**GILDA PUENTE-PETERS
ARCHITECTS**

**CITY HALL AND
CITY HALL ANNEX
ACCESSIBILITY SURVEY**

July, 2007

**CITY OF SANTA
BARBARA**

Building - Photo # 10

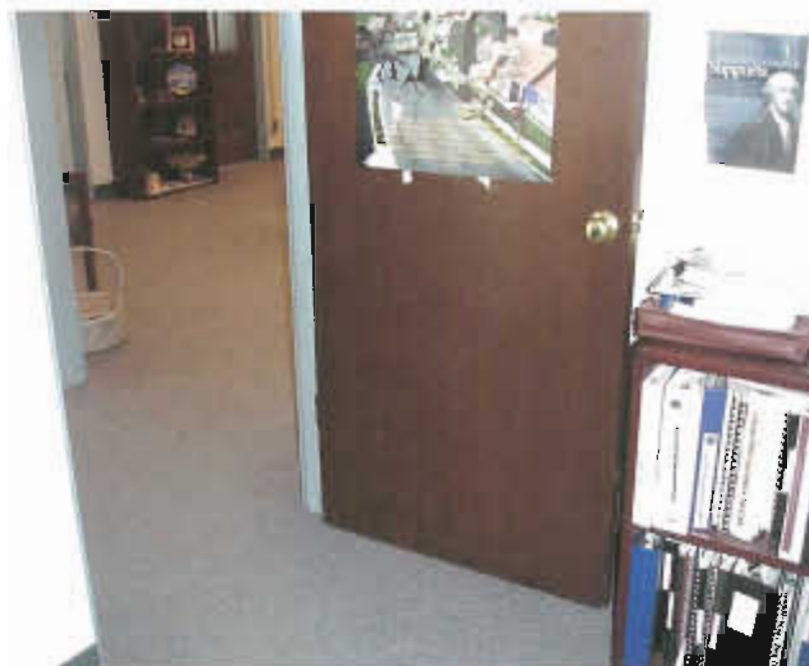
Doorknob requires tight grasping to operate. There is not the required tactile and Braille room identification sign. The credenza located in front of the door protrudes into the required door maneuverable clearance.

Building - Photo # 24

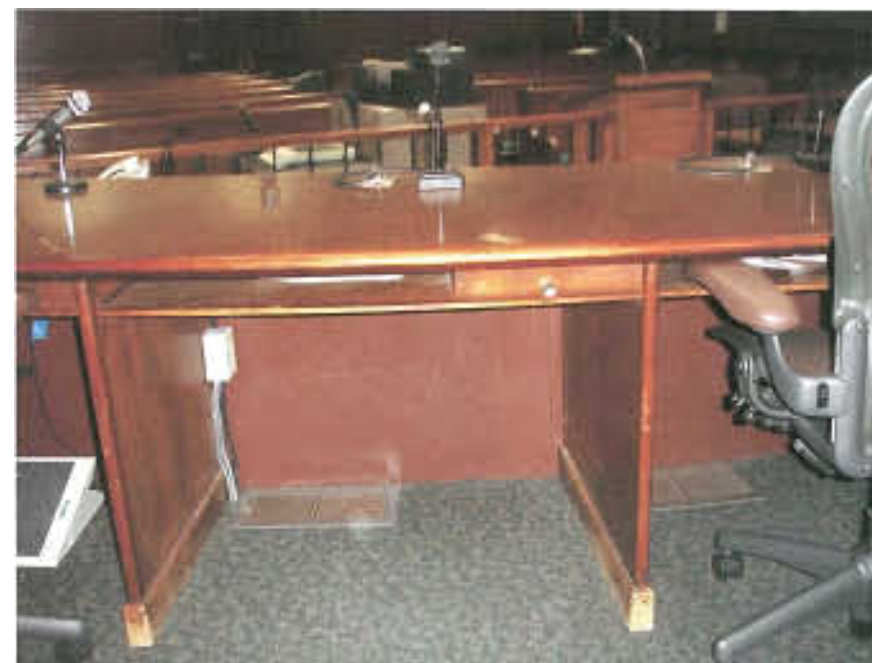
The City Council dais is not wheelchair accessible. There are no ramps to the first and second platforms. The gate is not wide enough for wheelchair users. There is not a smooth 10" kick plate.
